re: Clarification to notice in accordance with Article 16(1) of the Waste Management (Licensing) Regulations dated 23 March 2012

I am to refer to the above referenced application for a waste licence relating to a facility at Hollywood Great, Nags Head, The Naul, County Dublin. With reference to our notice under Article 16(1) of the Regulations and your request for clarification, I am to offer the following clarification as requested in your letter dated 19 April 2012.

Title		Proposed Landfill Cells Superimposed on Site Geology		Reference	A4
Location		Hollywood, Naul, Co. Dublin		Drawn by	JM
Client		Environmental Protection Agency (EPA) Ireland		Checked by	MF
Project No.	00146-014/JM	Date	March 2012	Project No.	00146-014
 <b>FORD CONSULTING GROUP</b> <small>environmental consultants</small>				Figure 2

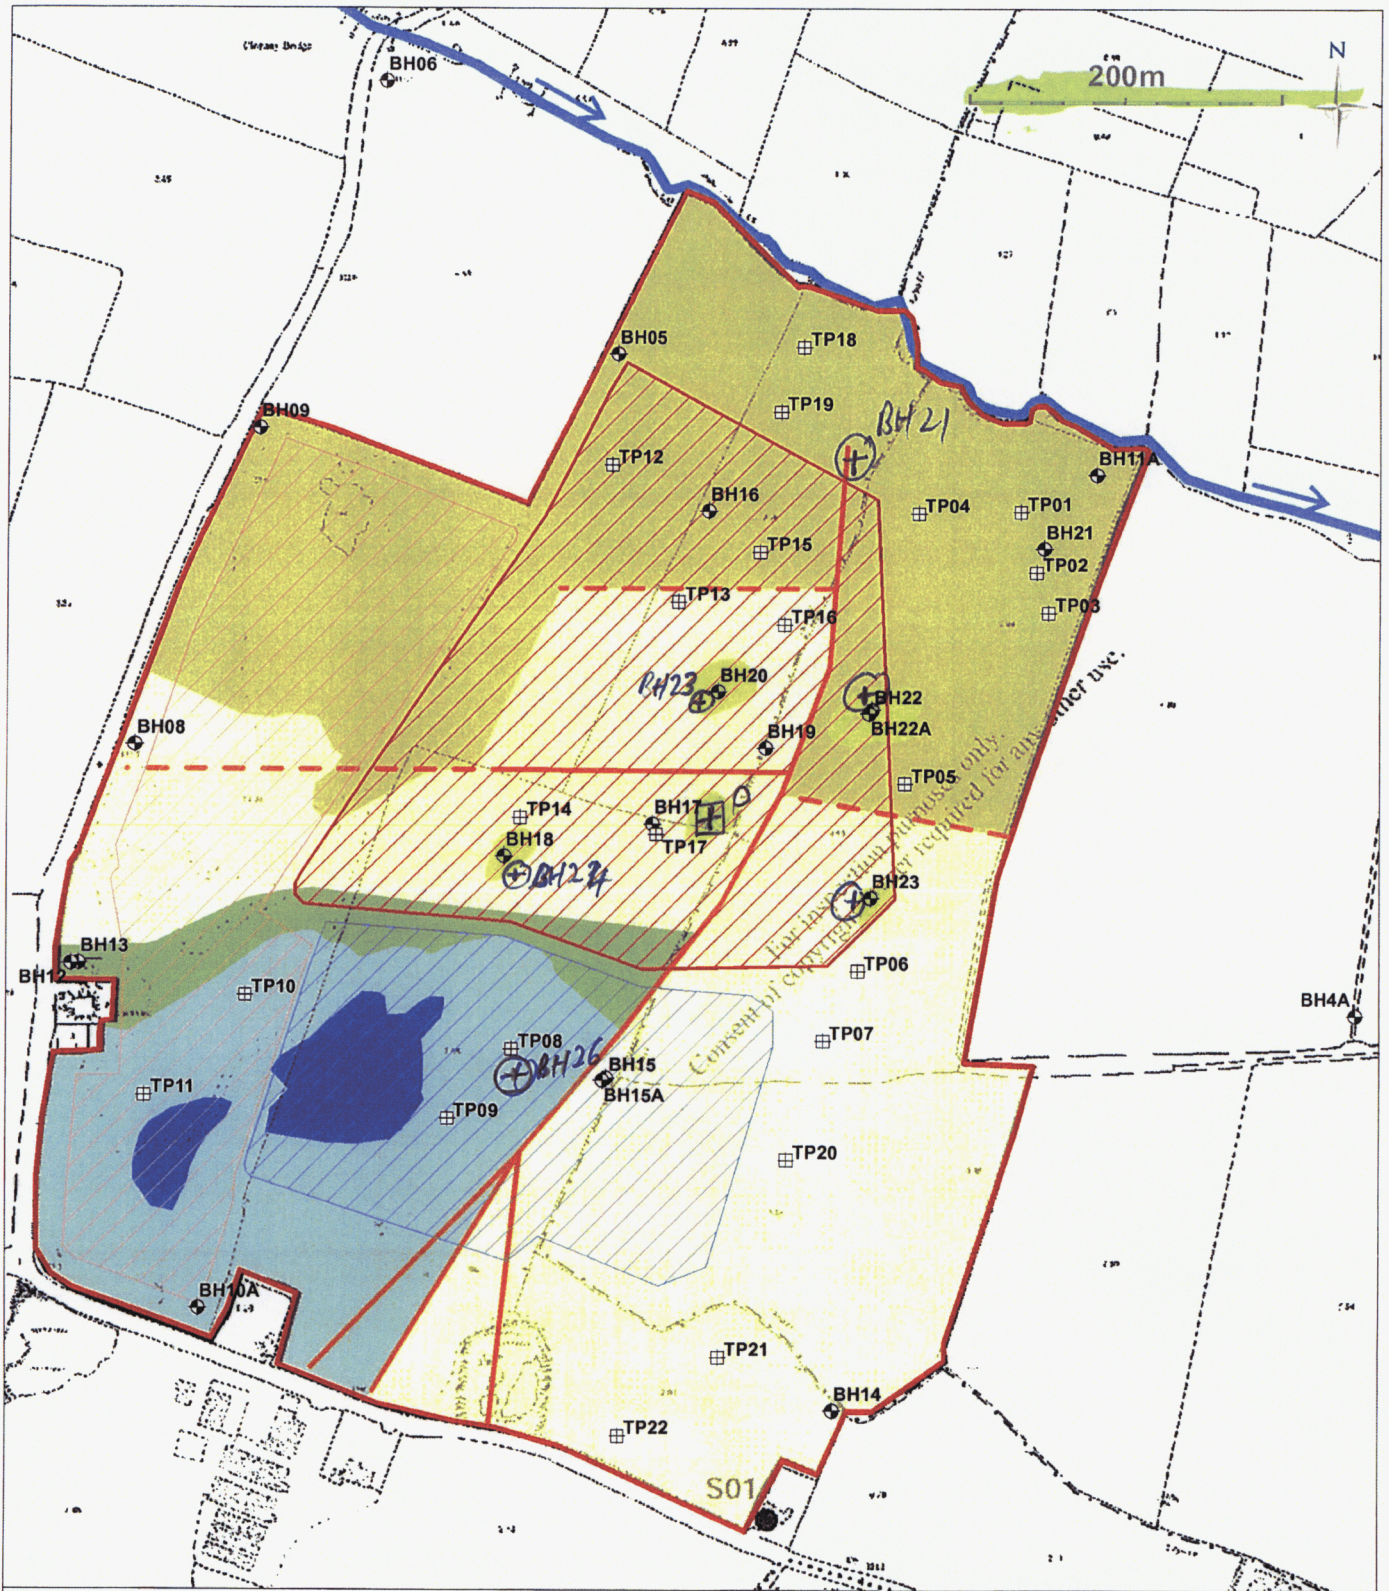
The proposed scope is not ideal and it is recommended that it be adjusted as set out below. The attached diagram illustrates the recommendations.

The four "well pairs" to be located in the four apparent fault blocks should not be so far apart. It may be preferable to have data points within 100-200m of each other. Therefore we suggest the following:

1. BH23 should not be next to BH16, but BH20. BH16 was drilled to 60m and did not report Loughshinny (it was cored so there's good data) and therefore another 60m well in this location will not "bottom out" the Loughshinny. It is considered that it may be better to have this second well closer to the fault system and therefore beside the existing well BH20. BH20 was not cored but is reported to be screened at the base of the Namurian. Therefore a second, deeper well targeting the Loughshinny should work at the BH20 location.

2. BH22 should not be in the northeast corner (too remote and Loughshinny apparently too deep). It may be appropriate for a new well pair to be installed close to the shallow borehole locations BH22/22A (in unconsolidated materials). It may be appropriate to install these two new wells to ~40m and ~60m depth and screened appropriately to be able to target the Namurian and Loughshinny, respectively.

3. BH24 next to BH18. BH18 appears to be screened in the Loughshinny at about 16-21m depth. It may be appropriate to install BH24 to 15m deep and screened between 5-15m (or thereabouts).

4. BH25 should not be in the southeast corner (too remote). A new well pair close to the shallow borehole location BH23 (in unconsolidated materials no water strikes to 23m depth) may be preferable with two new wells installed to ~40m and ~60m depth and screened appropriately to be able to target the Namurian and Loughshinny, respectively.

1. The well in the non-hazardous cell (BH26) might better serve as a monitoring well, not the pump test well.
2. Proposed well to the north (BH21) targeting the fault zone. It may be preferable for this well to be closer to the suggested end of this north-south fault (on your plan) and not at the north boundary of the site. It is designed to intercept the fault zone in this area. With this as the target our sense is having two wells one to 40m depth (screened 20-40m) and a second to 60m (screened 40-60m) may be better than the 90m option, recognising we may not reach the Loughshinny.

3. The pump test well may not usefully be BH26 (believed to be too remote from the main fault block intersection and area). The original pump test well (BH17) location was good, it was just the well was screened across the Namurian and Loughshinny so not that useful in this sense. Therefore it may be that a new pump test well about 25m east of existing BH17 (not too close to it) towards the main north-south fault, but not too close to it, is appropriate.

Not all boreholes need to be cored. However at the proposed locations near existing boreholes BH20, BH22/22A and BH23, coring the deep borehole would help a lot to understand the geology and aquifer units and fracture distribution and therefore could be invaluable. The pump test well might also of course benefit from being cored. If four is seen as prohibitively expensive then it may be appropriate that the pump test plus one of the two boreholes to the east of the main fault are prioritised for coring (so 2 not 4 cored).

It is noted that the MEHL numbering system for the proposed new wells should be changed as there are already boreholes with the same reference (e.g., BH22 and BH23) which will be confusing later.
